Re: ACTION RE: PETITION FROM FOX TRAIL DEVELOPMENT, LLC. REQUESTING SITE PLAN AND DESIGN REVIEW FOR THE CONSTRUCTION OF A SINGLE-TENANT OFFICE BUILDING LOCATED AT 2110 & 2120 RIVERSIDE DRIVE, PARCELS AL-63 & AL-64 (current vacant lot)

Site Plan & Design Review – Staff Comments (reviewed 12-16-2023)

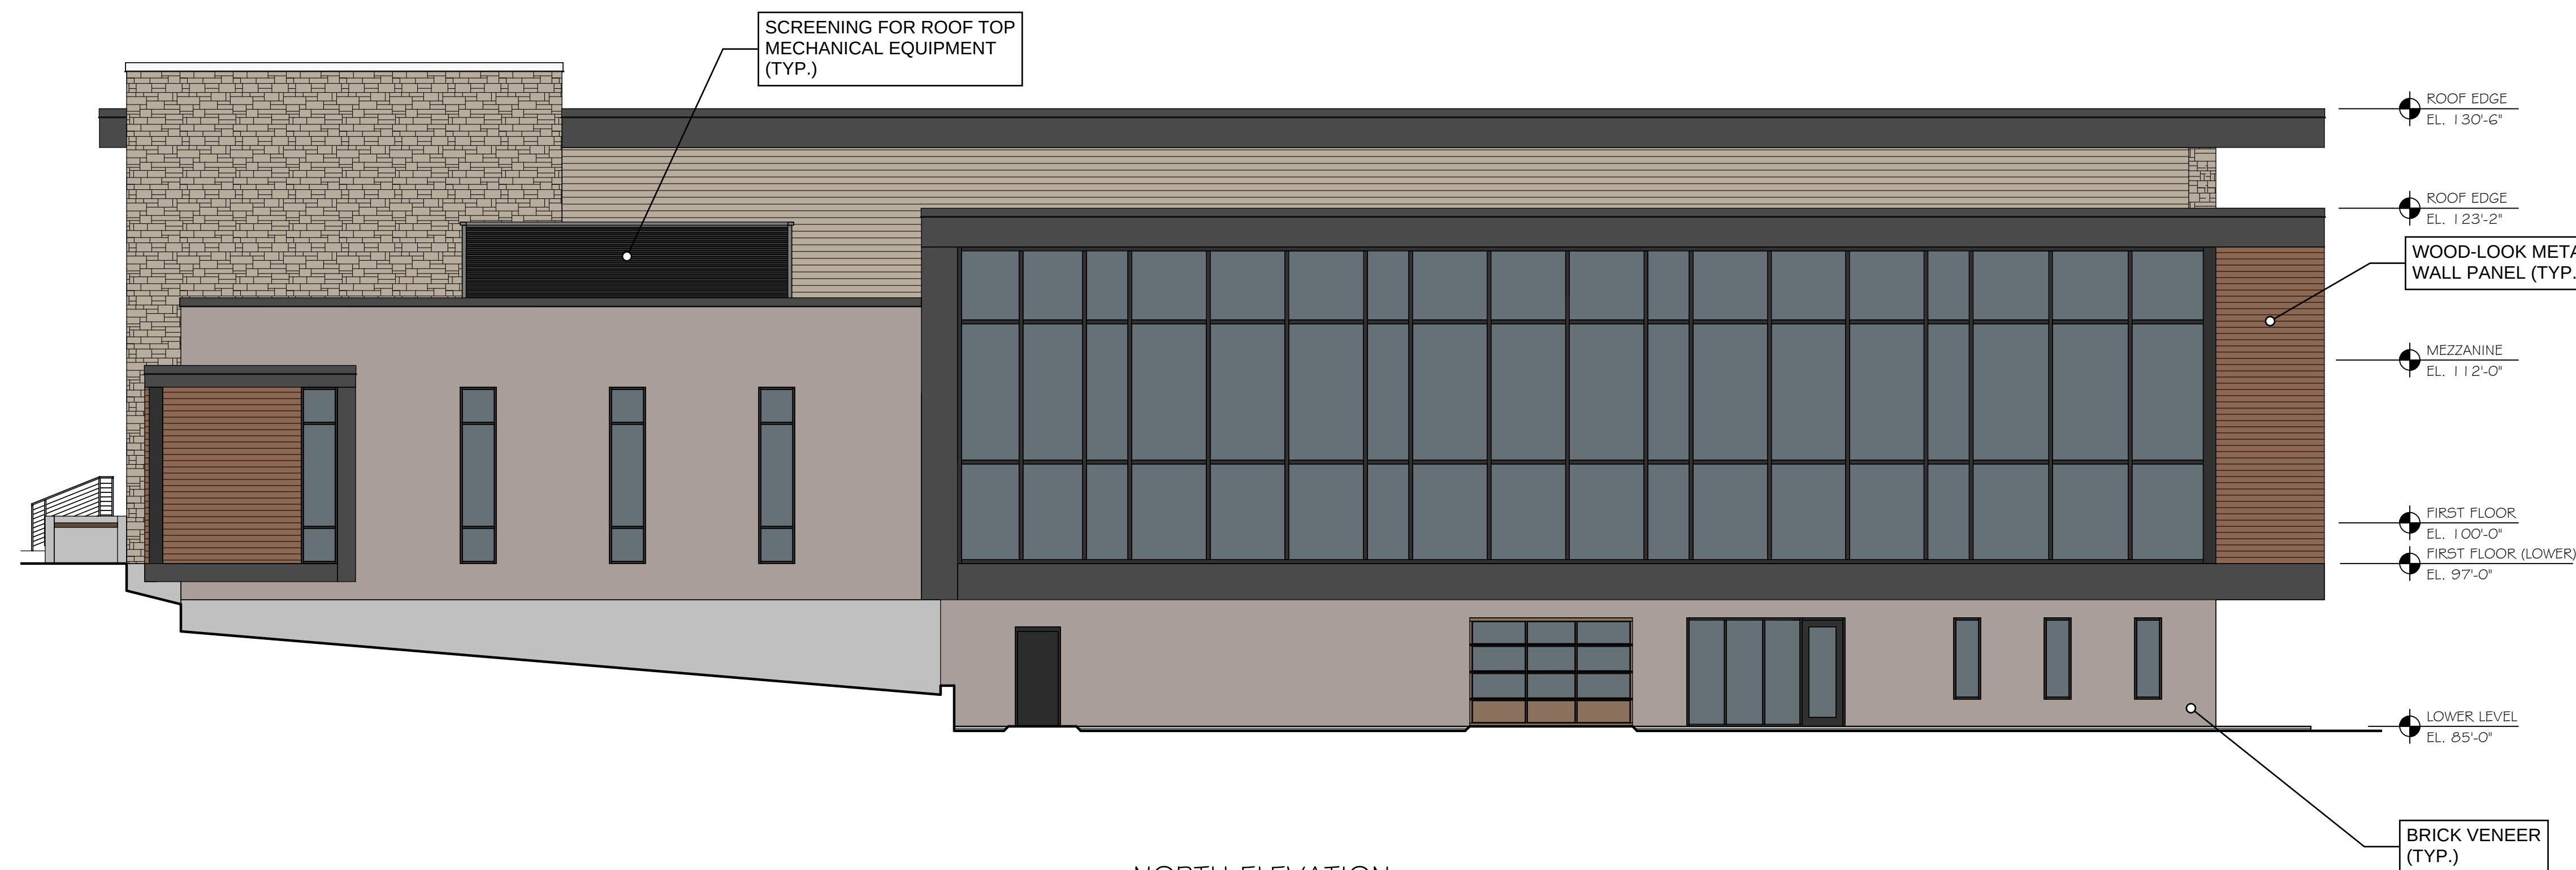
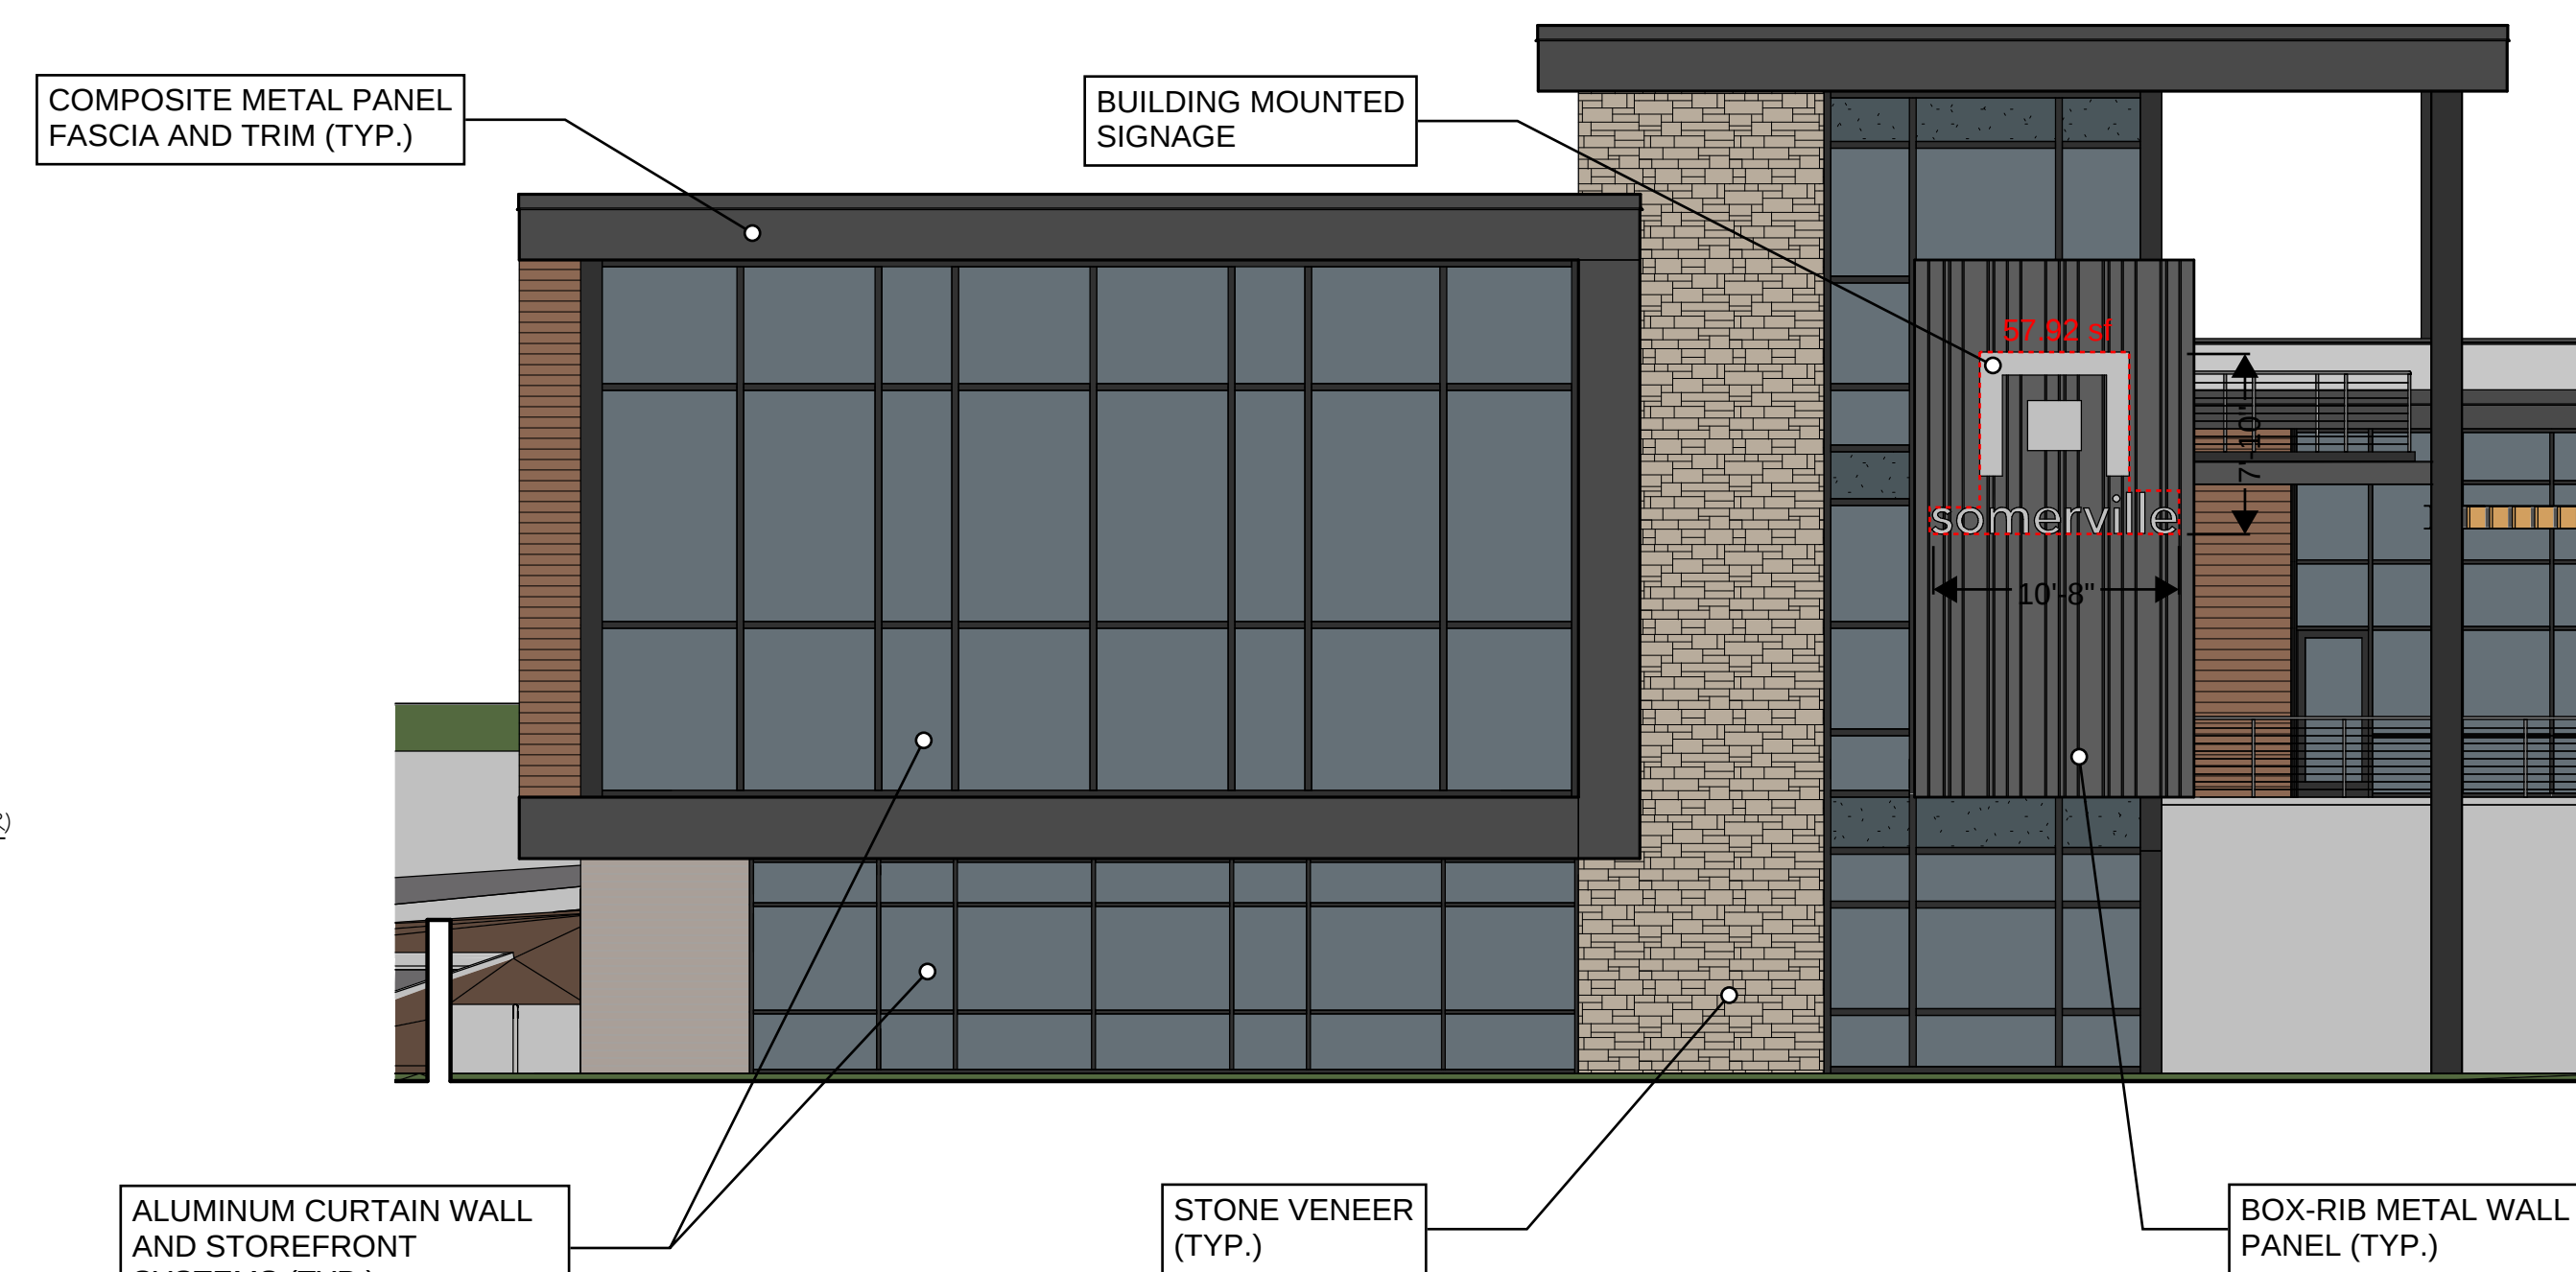
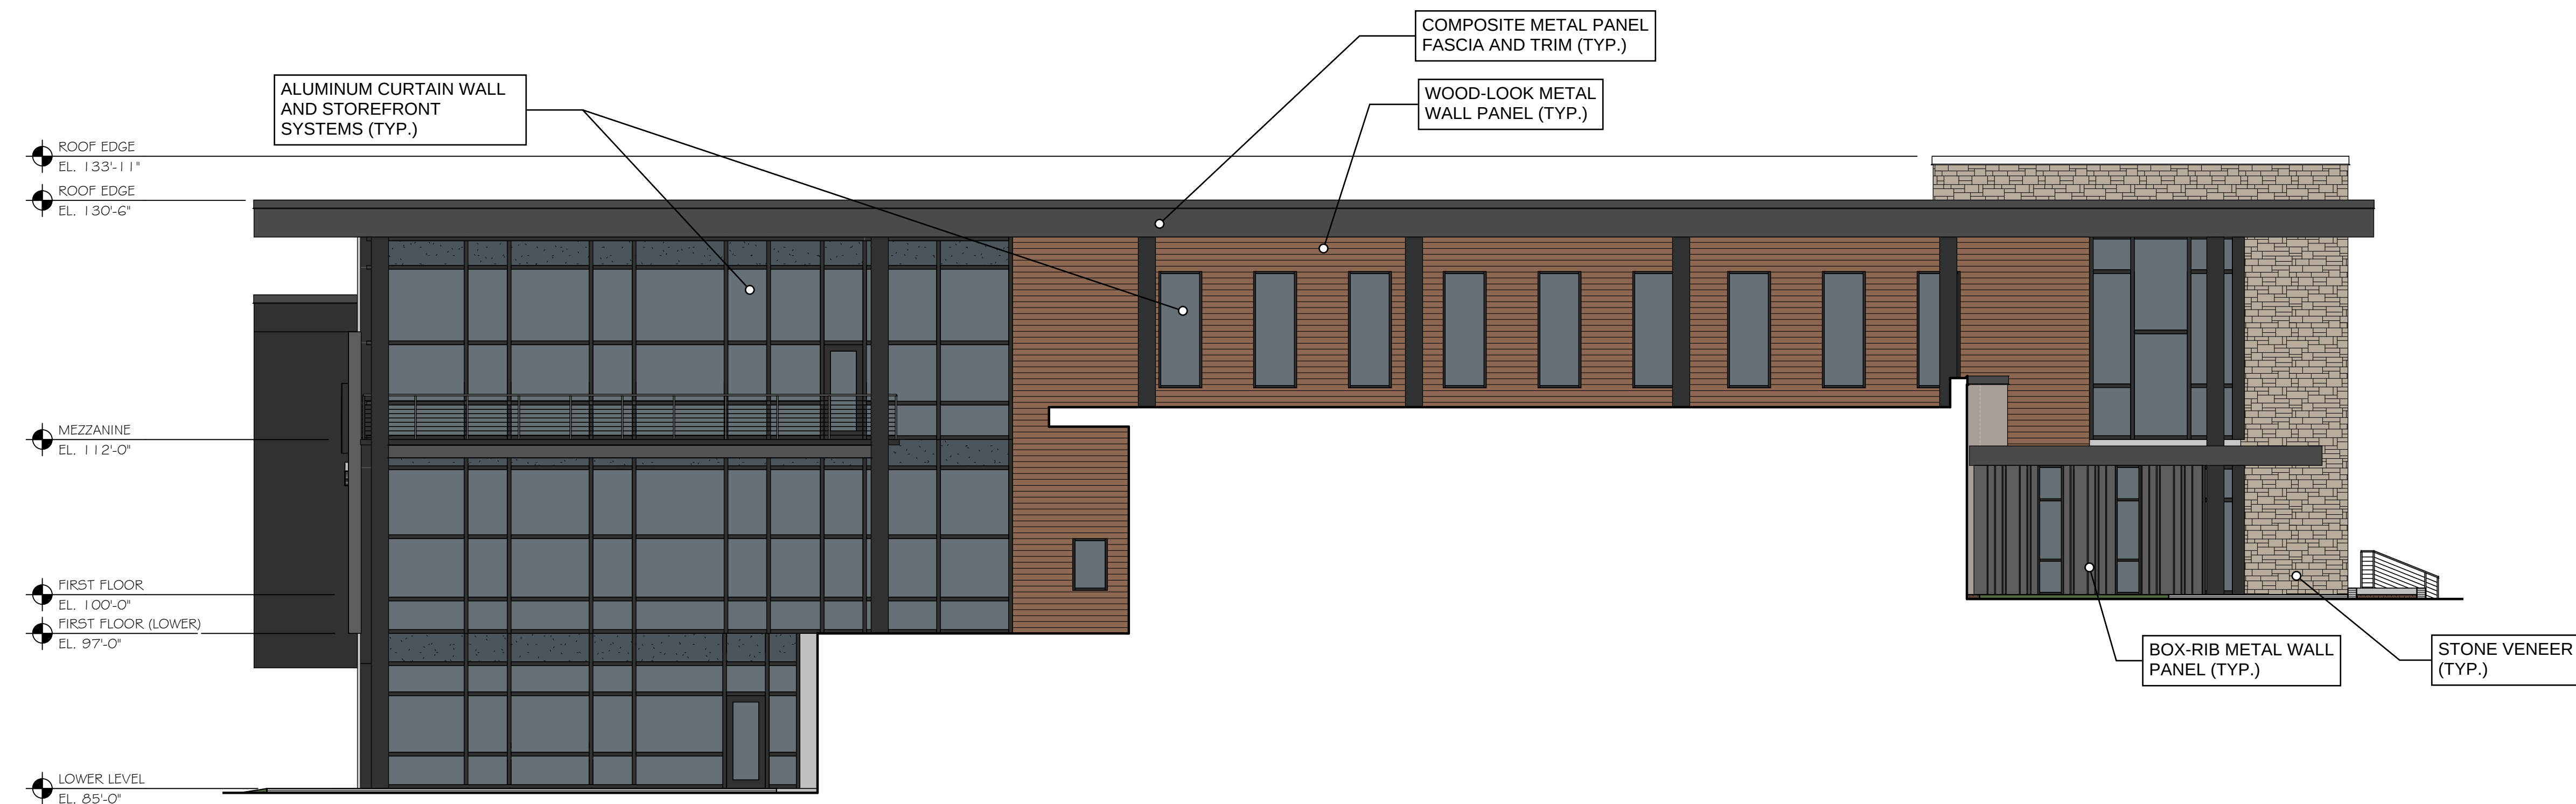
- Zoning Section 475-901C & 475-901 D:
 - Standards appear met for major and minor façade material. Staff will work with project architect to verify final material make-up.

- Zoning Section 475-901Q:
 - Standards appear met for screening of mechanical equipment. Staff will work with project architect to verify final screening.
